Planning Commission

Agenda Item #7a O'Reilly Auto Parts Site Plan Review Request

Webb Architects, representing O'Reilly Auto Parts of Springfield, Mo, is requesting site plan approval for their new store proposed for 369 Blue Star Highway. City departments have reviewed the plans and have offered comments as has the zoning administrator. Those comments are included in this agenda and have been forwarded to the applicant. The applicant is working on addressing the comments and will be prepared to discuss those items at the meeting.

PROJECT:
 NEW O'REILLY AUTO PARTS STORE
 BLUE STAR HIGHWAY
 SOUTH HAVEN, MICHIGAN

SHEET
ALTA/ACSM Land Title /
Topographic / Tree Survey

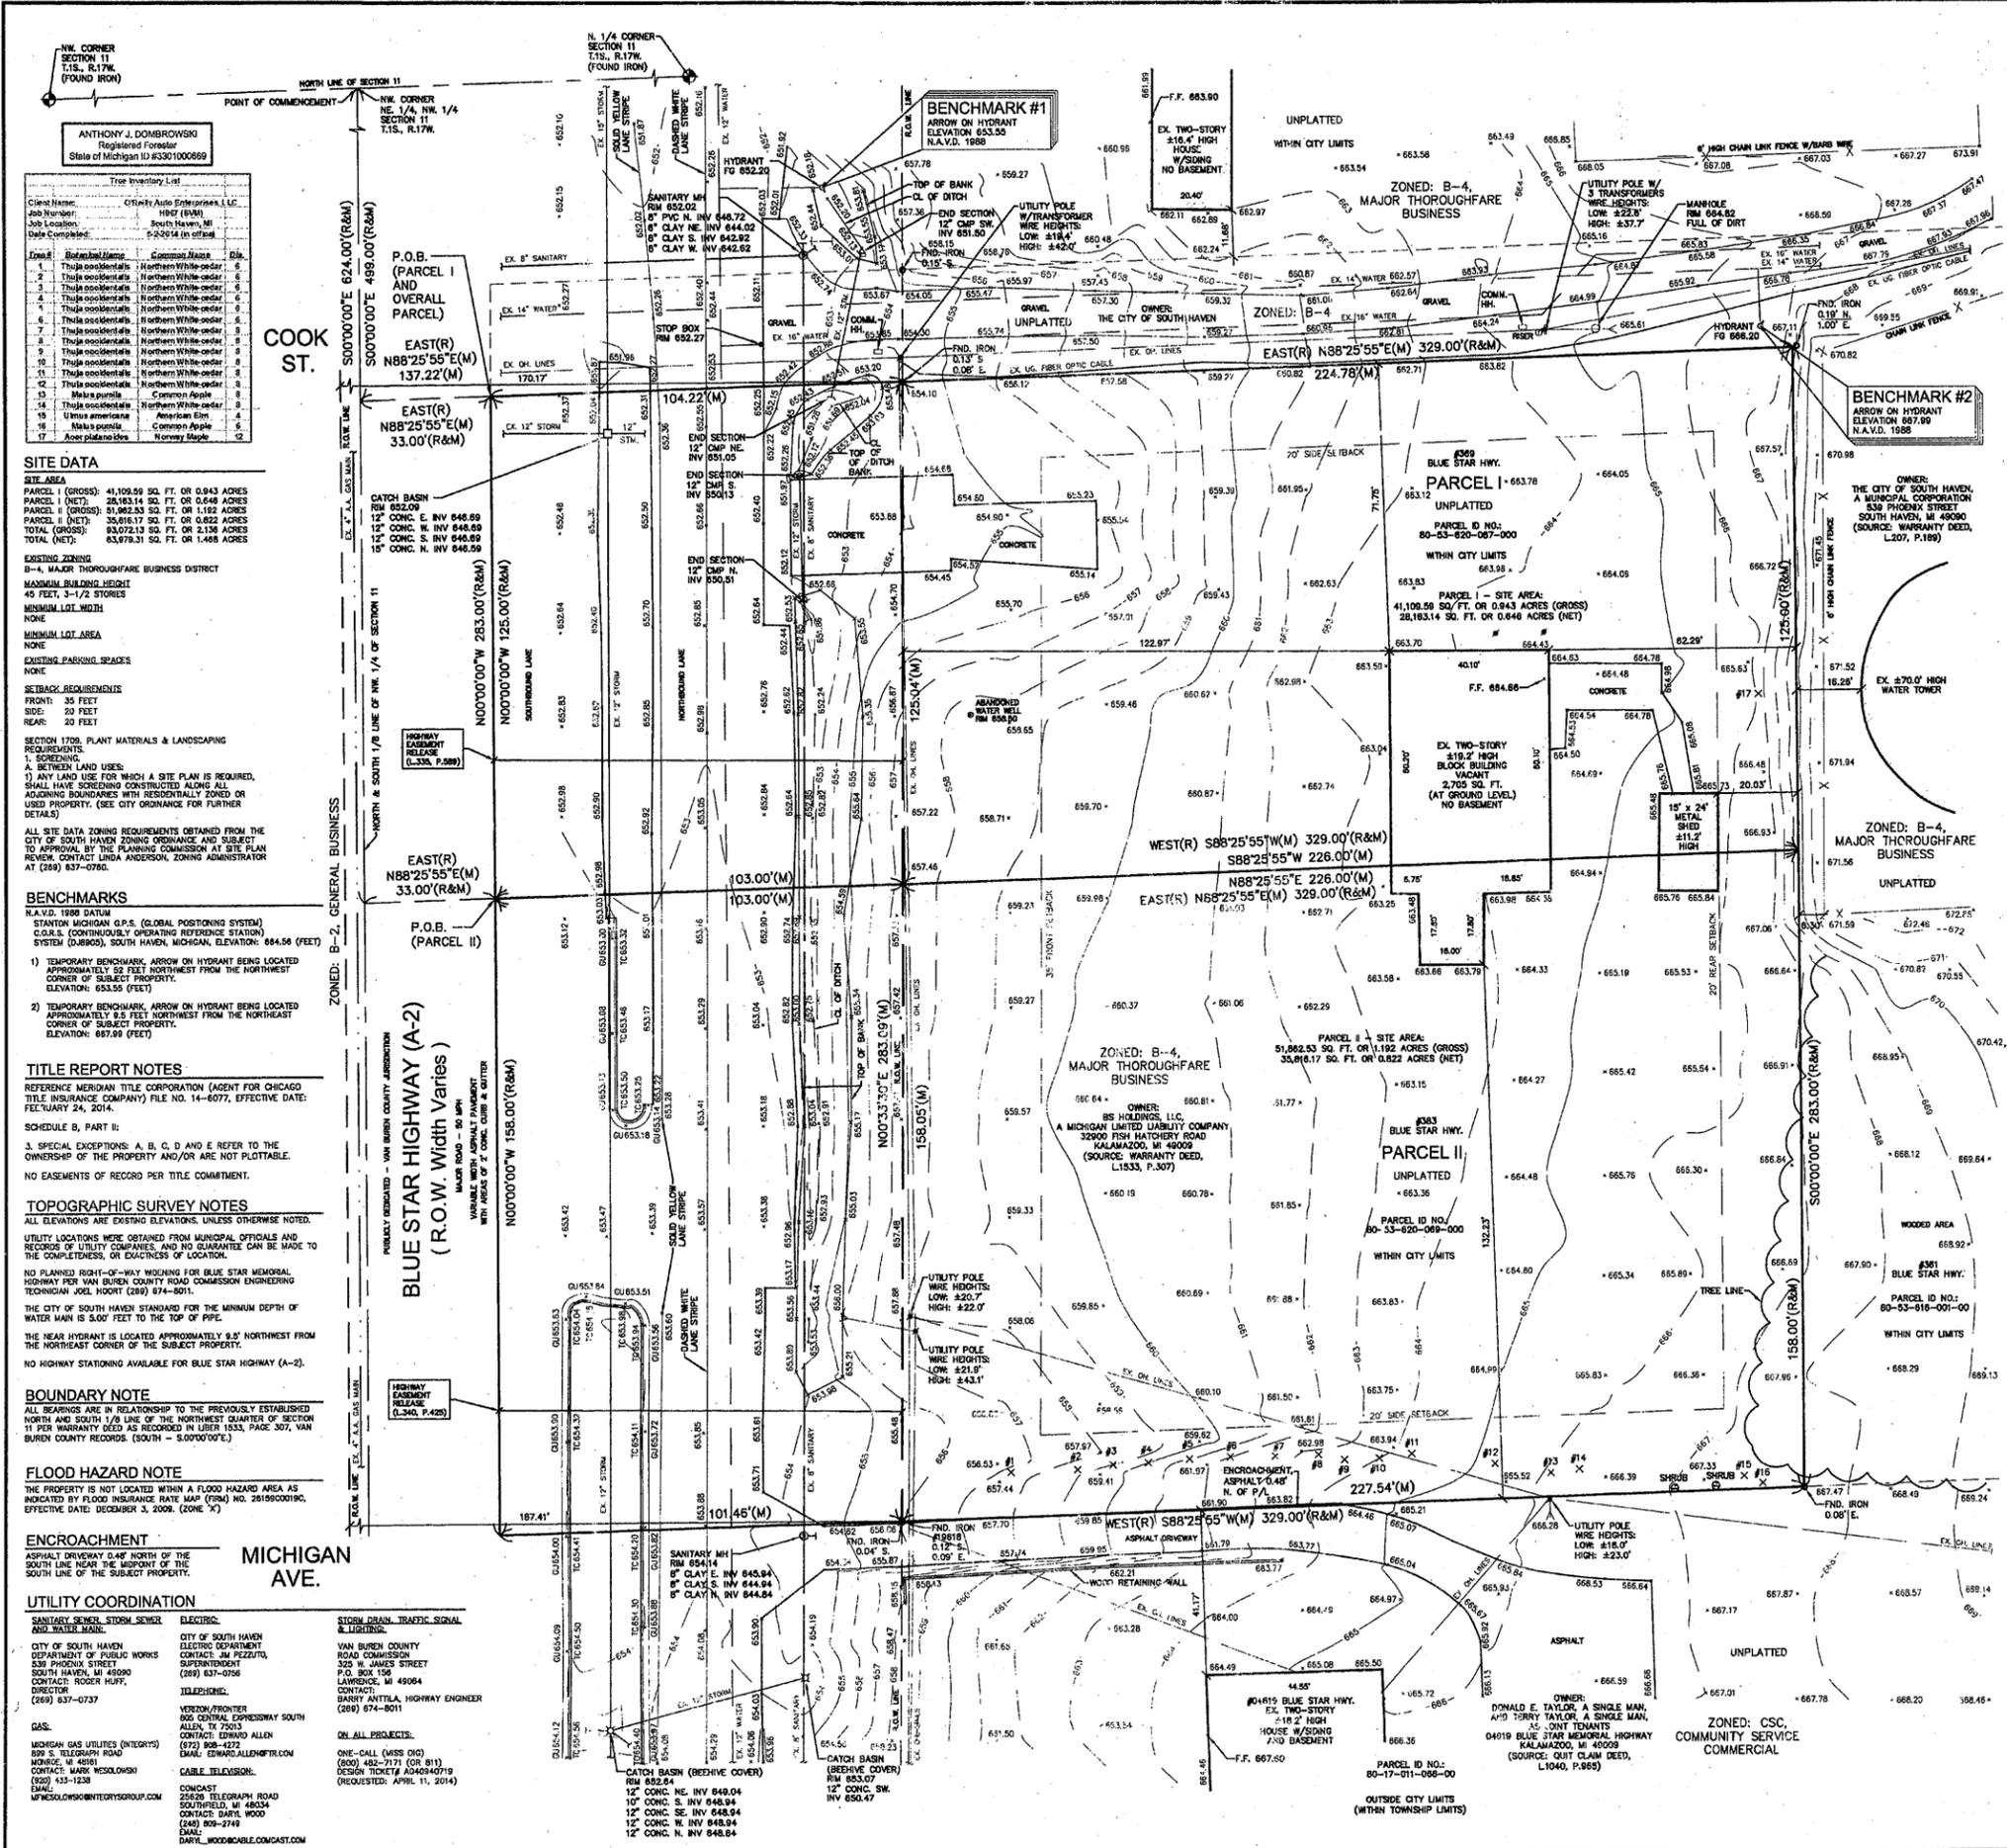
1. The setback requirements on sheet SV1 are incorrect for the overlay zone (setbacks on plan drawing are correct)
2. A driveway permit is needed from VBCRC (Staff understands this is in progress)

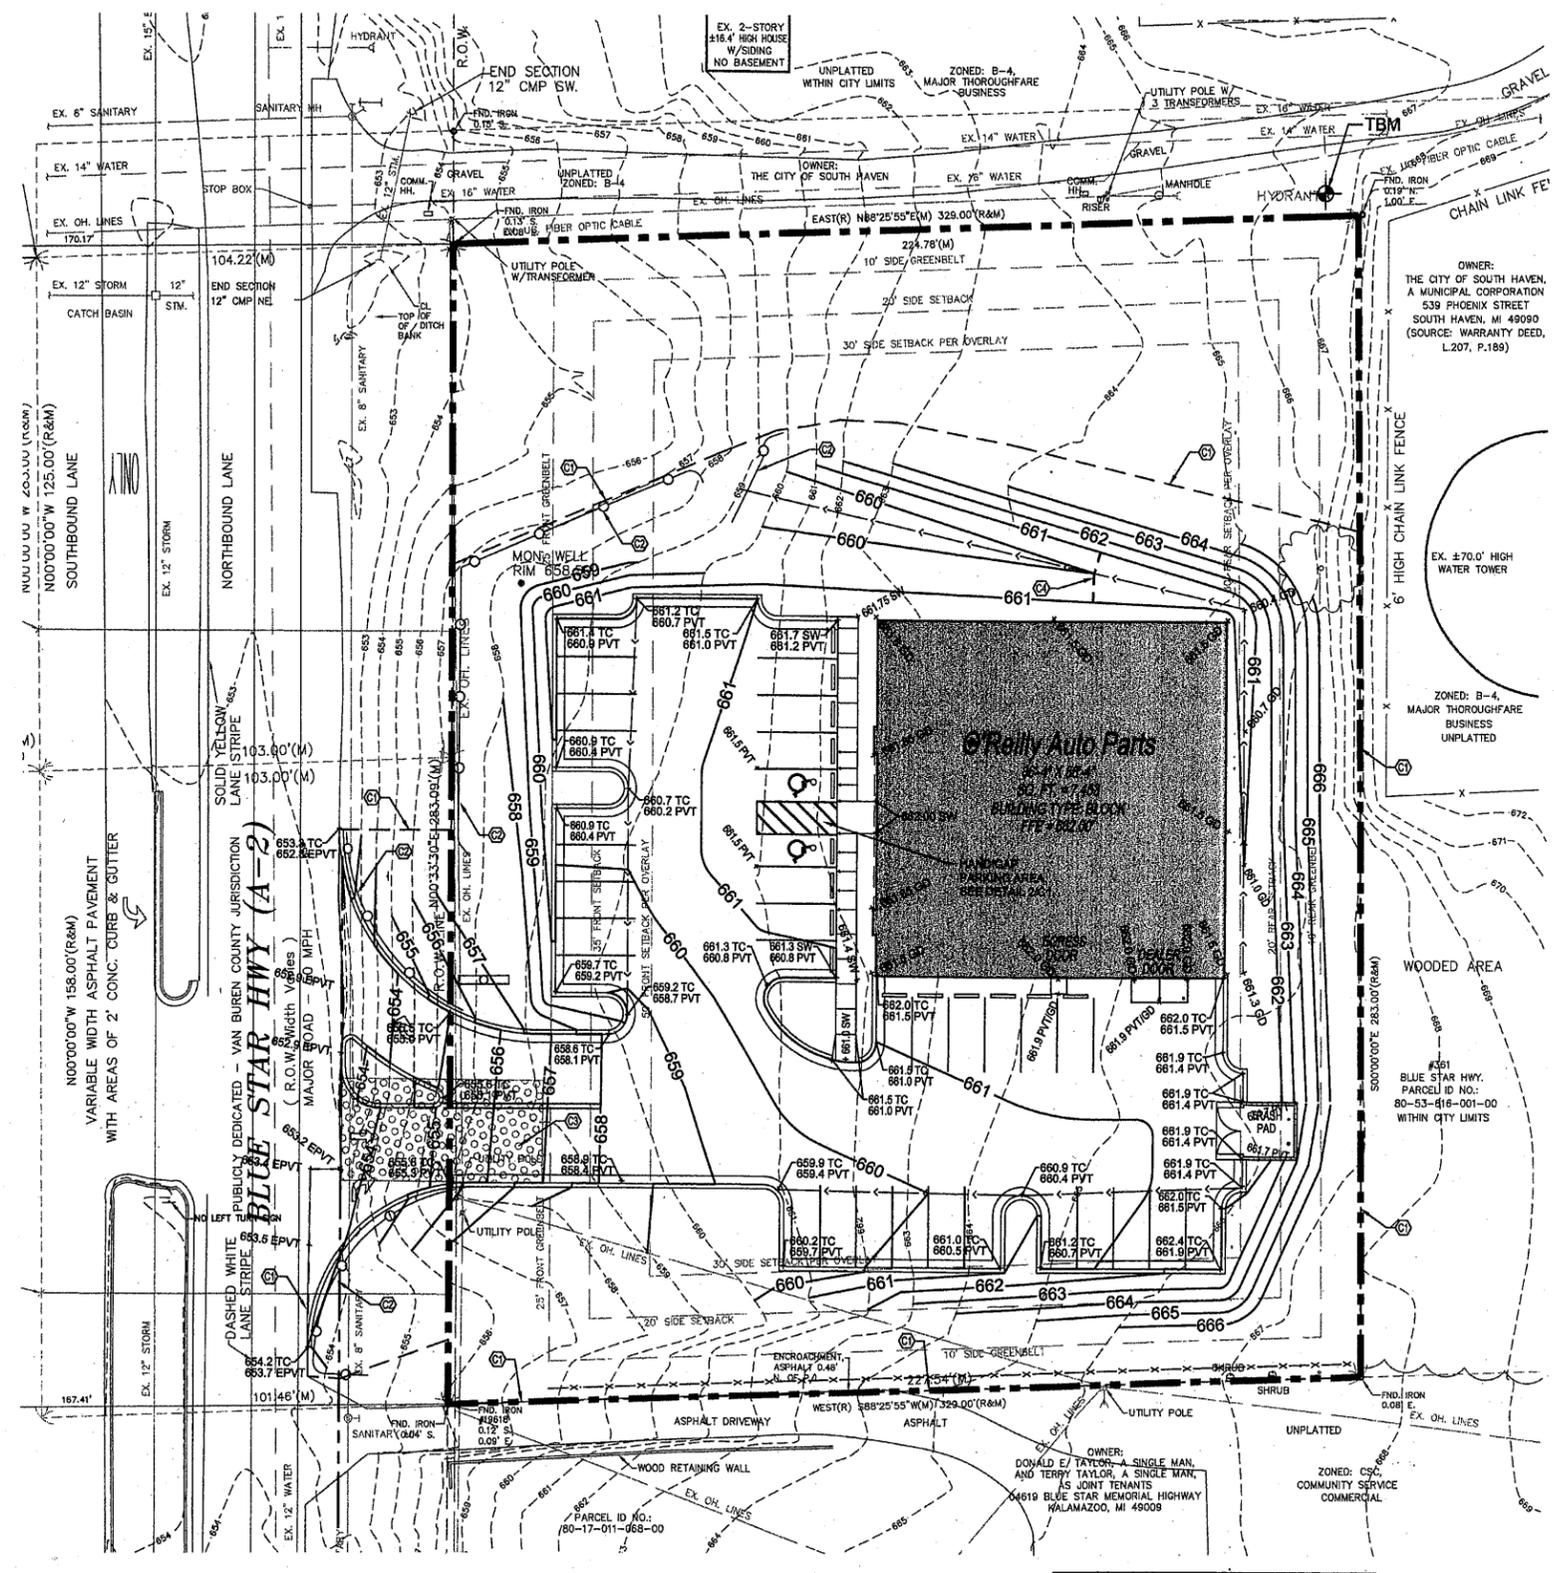
Drawing sheet C1 indicates that storm water runoff will be managed by surface runoff into Blue Star Highway. This method of accommodating storm water runoff is not acceptable. This site must be developed with on-site storm water detention for a 25-year storm event with a release rate not to exceed 0.13 cfs per acre. Appropriate conveyance facilities must be designed to convey runoff to the detention basin. These may consist of storm sewers and catch basins, drainage swales and ditches, or direct surface runoff.

1 SITE DEVELOPMENT PLAN
 C2 SCALE: 1" = 20'

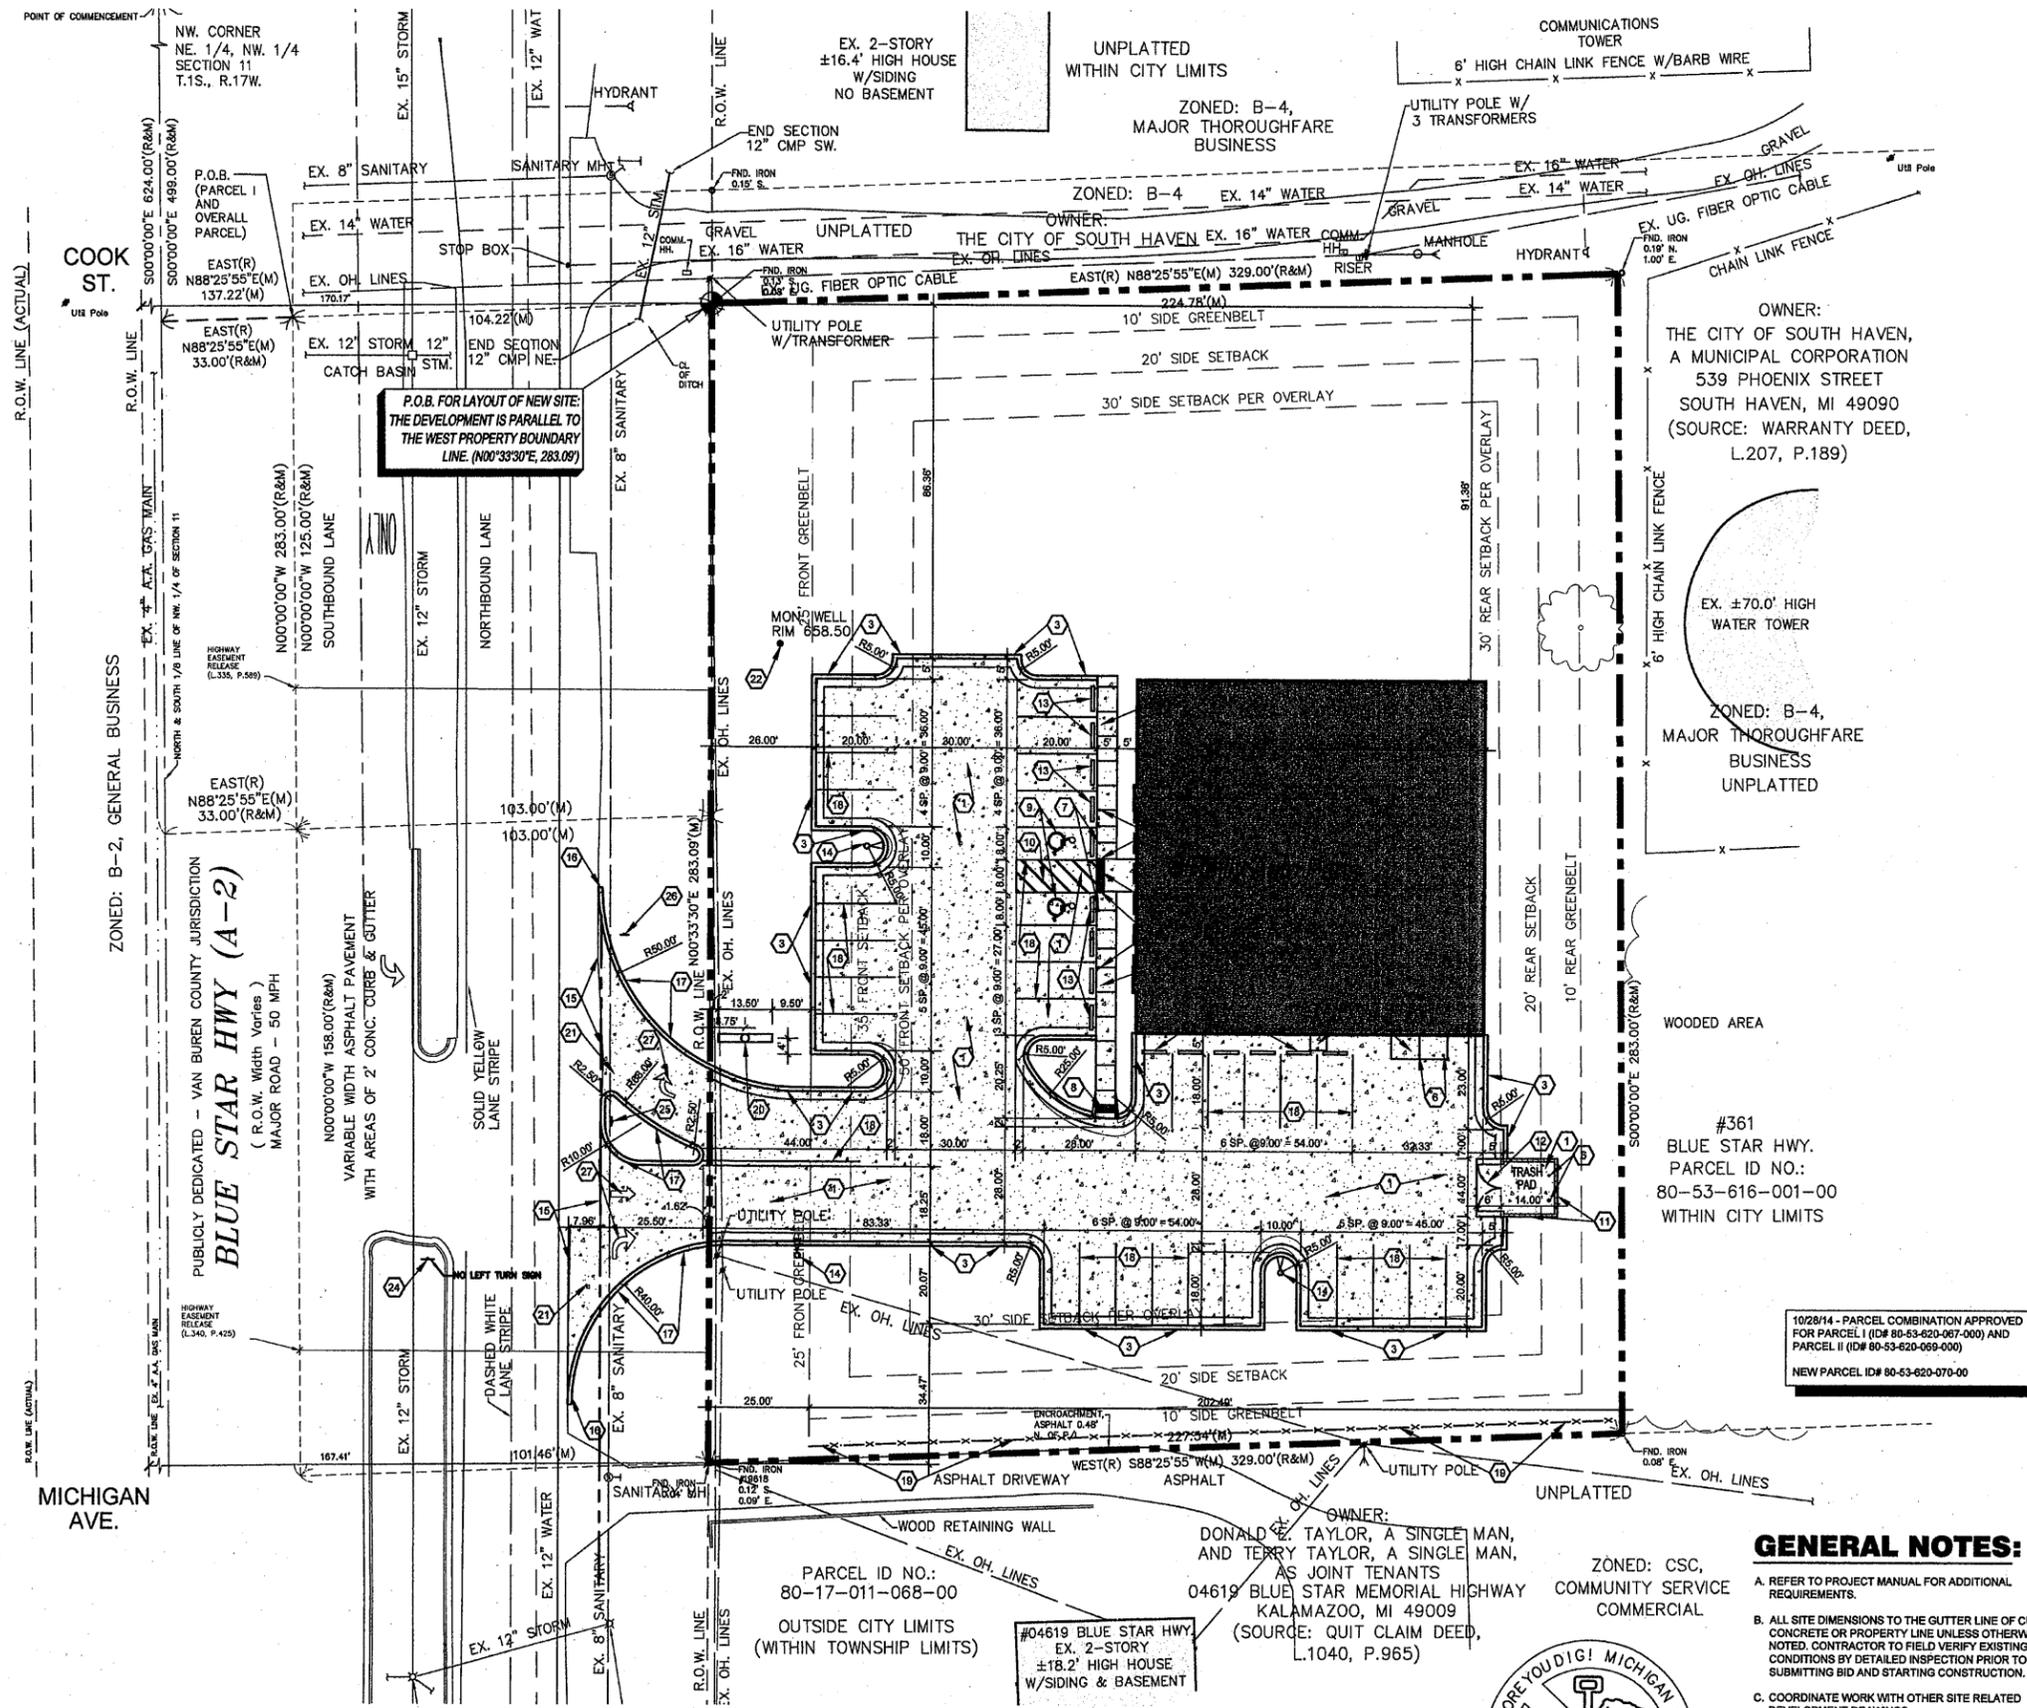
Drawing sheet C2 indicates several lane use arrows at the site entrance driveway. Arrows for entering traffic are not necessary. The right turn arrow for exiting traffic is necessary and should be supplemented with an ONLY legend painted on the pavement. The arrow and ONLY legend should be painted white, not yellow as called out in note 27. In addition to the stop sign, a R3-5(R) sign (right turn only) should be placed at the exit driveway.
